SERVICE BULLETIN

No. D-11

Parking Brake
Adjustment

D41 - D42

FIGURE 1

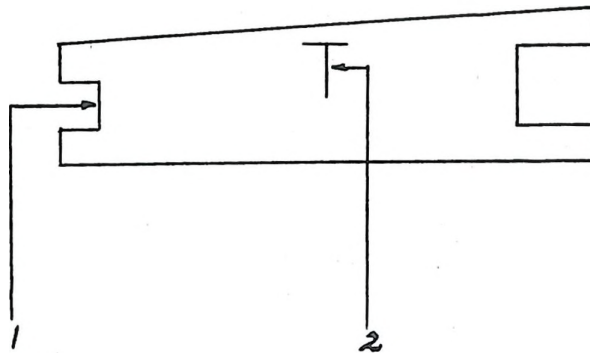
1. File bottom of this opening.
2. Install link with "T" on top side.

When the link is correctly installed and excessive up and down movement is still noticeable, remove the link and file the small slot in the link (Fig. 1) until the shoe fits snugly against the anchor stud, and the lower end of the operating lever does not ride on the brake shoe. This lever should have some free movement, with the brake cable disconnected from the lever. Do not remove any more metal than necessary, as excessive filing will cause the link to rattle and will increase the brake lever travel, thereby decreasing the efficiency of the brake.

It should always be installed with this identification at the top. This is very important.

FIGURE 2

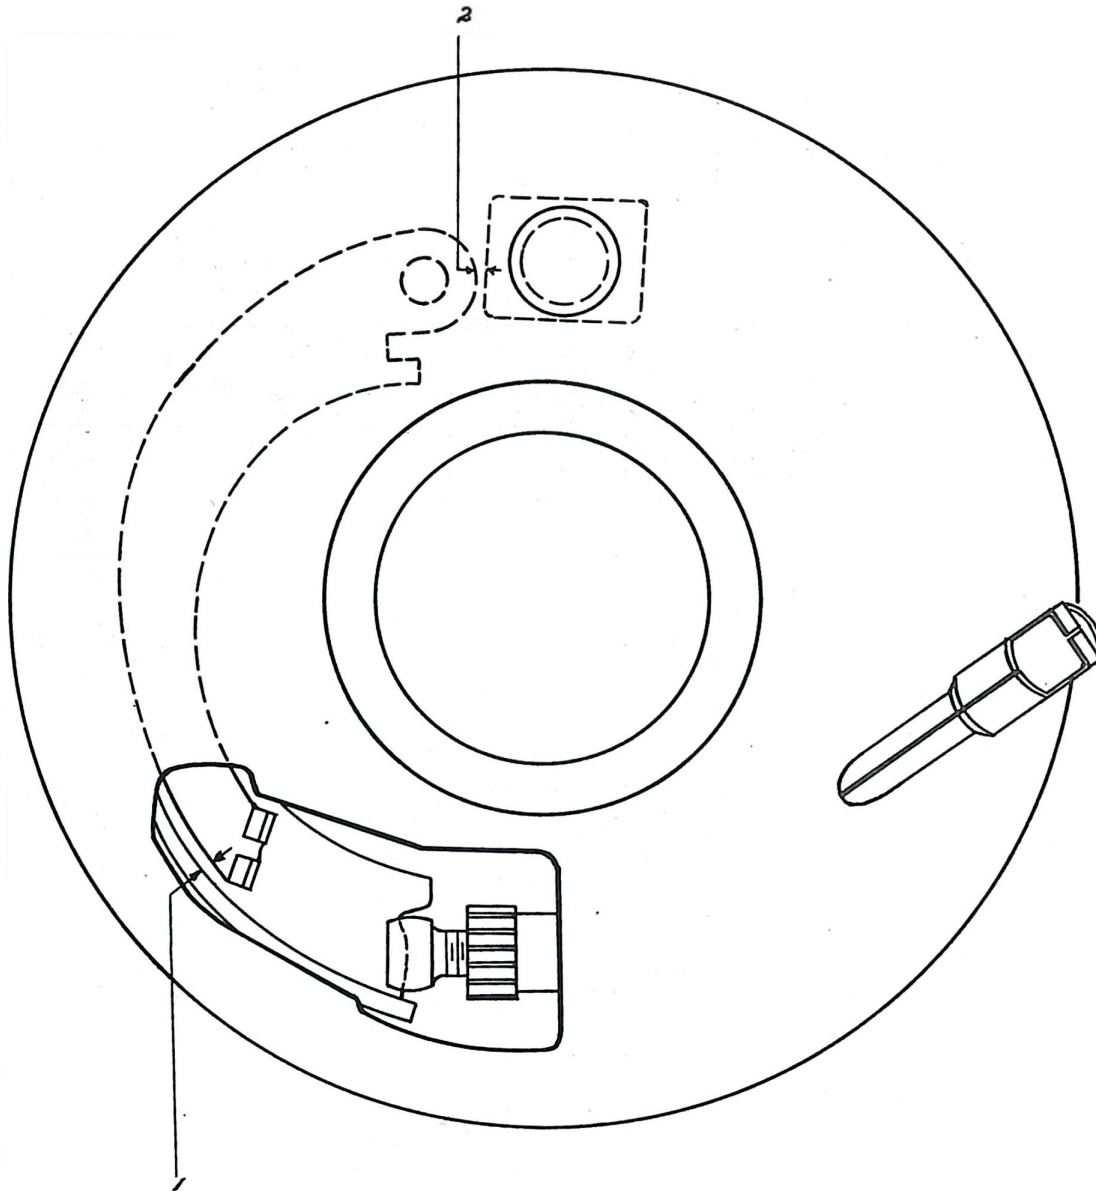
(1.) Lever must not contact brake shoe--must have small amount free play when cable is detached. (2.) Must have clearance at this point.

FIGURE 1

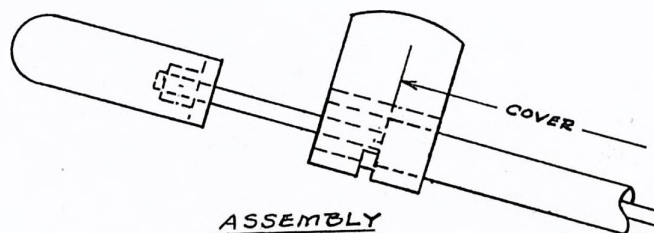
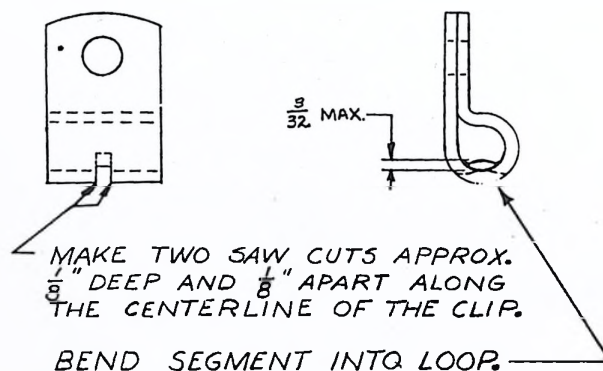
A relatively simple correction can be made by forming a stop in the middle of the clip as shown in the following sketch, thus forcing the cover farther down the cable.

Care should be taken that the clip still has sufficient clamping force to prevent the cover from being forced out of the clip when releasing the brake. The stop should not extend into the loop of the clip more than the 3/32" shown on the sketch or it may interfere with the cable itself.

FIGURE 2

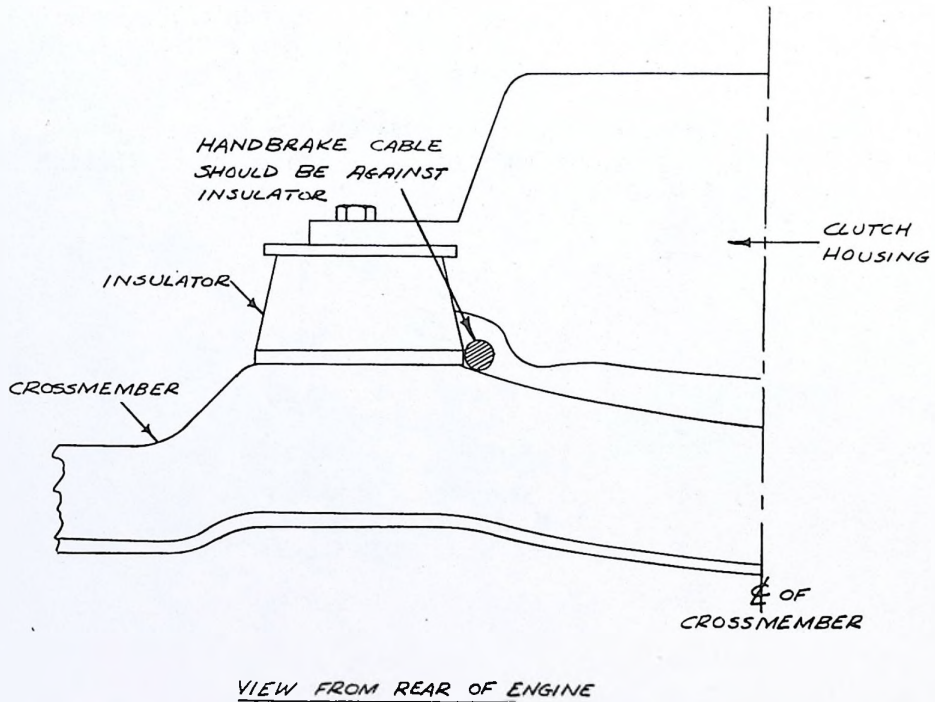
Another condition may exist that will also affect the operation of the brake and that is the improper location of the brake tube and cable assembly. Instances have been found where the brake tube assembly have been jammed between the clutch housing and the crossmember which damages the tube and will interfere with the proper operation of the brake. This condition may result in complaints of rough engines or idle, as the tube will not allow the engine to move on the rubber mounting.

The brake cable assembly should be installed as shown on the following sketch.

FIGURE 1

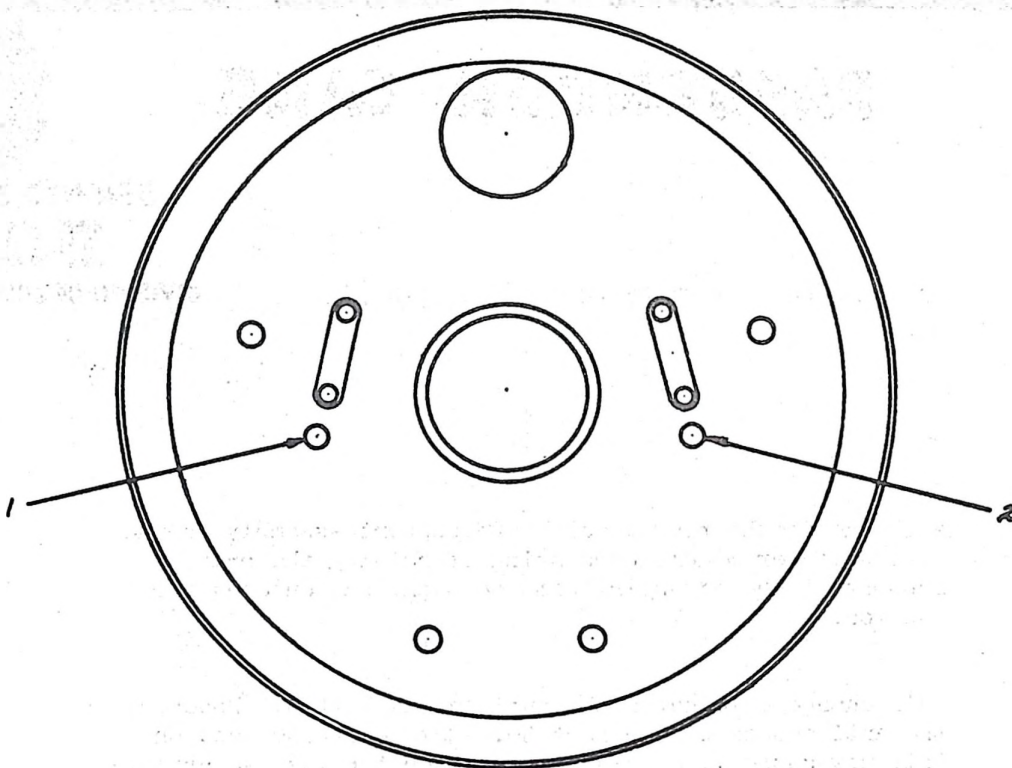
A change in the rear wheel brake support assembly on the D-41 Wayfarer models consisting of raising the brake support at the adjusting cam location, has entered production.

This change eliminates the anti squeak button. However, the anti squeak washer Part No. 1327054 can be used on this new support, should the occasion for its use arise.

Under no circumstances should the anti squeak button be used, as it will result in cocking the brake shoe out of line.

This new brake support can be readily identified by a raised circular section approximately 1/16" high by 3/8" in diameter, directly below the brake shoe hold down clip rivets.

The Part Number of the new brake support is #1404983.

Effective at Serial Number 37163562.
